Rules and Regulations for the Classification of Ships, July 2006

Notice No. 5

Issue date: March 2007

This Notice contains amendments within the following Sections of the *Rules and Regulations for the Classification of Ships, July 2006.* The amendments are effective on the dates shown:

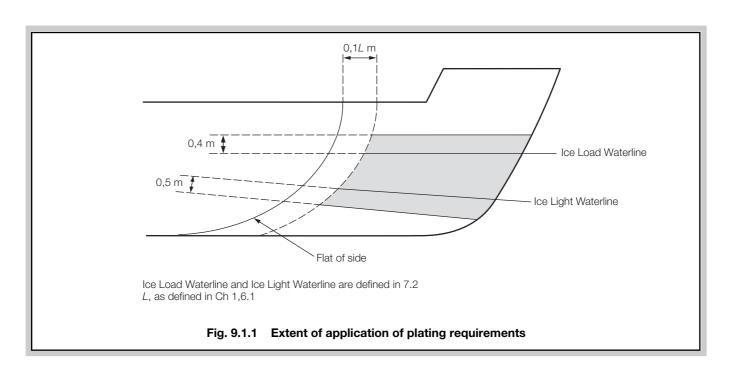
6.1.5 The requirements for Ice Class **IE** are for offshore supply ships, as defined in Pt 4, Ch 4, and are intended to navigate in very light first-year ice conditions, such as in brash ice and small ice pieces. The requirements of Section 9 are to be complied with.

6.1.6 For ships where the ice class notation Ice Class 1AS FS(+), Ice Class 1A FS(+), Ice Class 1B FS(+) or Ice Class 1C FS(+) is requested, the requirements of the Finnish Swedish Ice Class Rules in force at the time of contract, and Section 7, and Pt 5, Ch 9,4 are to be complied with.

6.1.6 6.1.7 The requirements for strengthening for navigation in ice, as given in Section 8, are intended for ships operating in multi-year ice in Arctic or Antarctic ice conditions under their own power.

Table 14.2.4 Crew work areas – maximum noise levels in dB(A)

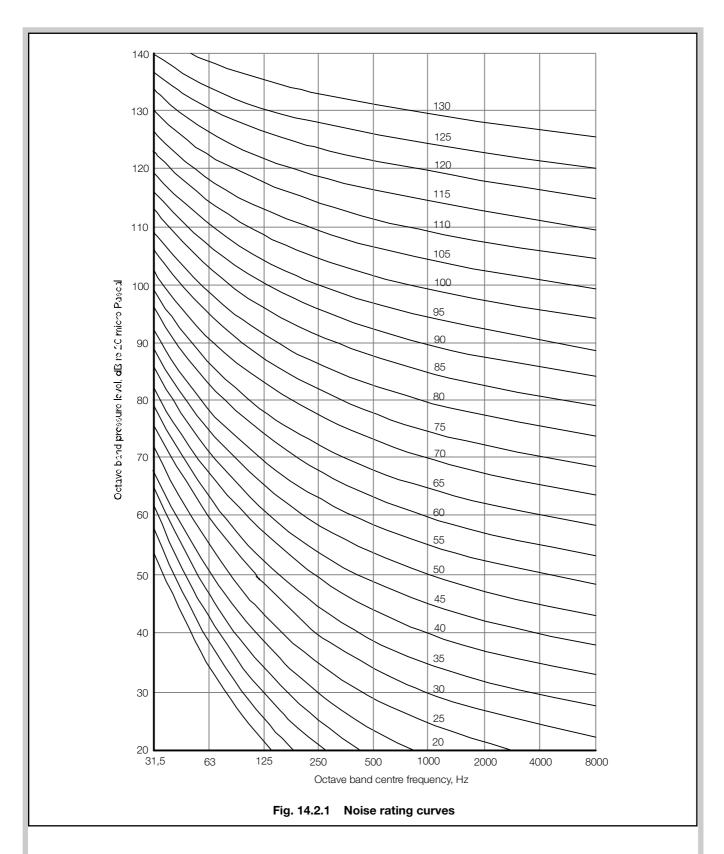
The levels may be exceeded by 5 dB(A) within 3 m of a ventilation inlet/outlet or machinery intake/uptake on open decks.

Location	dB(A) level
Machinery space (continuously manned) e.g. stores	90
Machinery space (not continuously manned) e.g. pump, refrigeration, thrusters or fan rooms	110
Workshops	85
Machinery control rooms	75
Wheelhouse	65
Bridge wing, additional limits:  250 Hz band  500 Hz band	68 63
Radio room	60
Galleys and pantries:  Equipment not working Individual items at 1 metre	75 85
Normally unoccupied spaces (e.g. holds, decks)	90
Ship's whistle, on bridge or forecastle	110
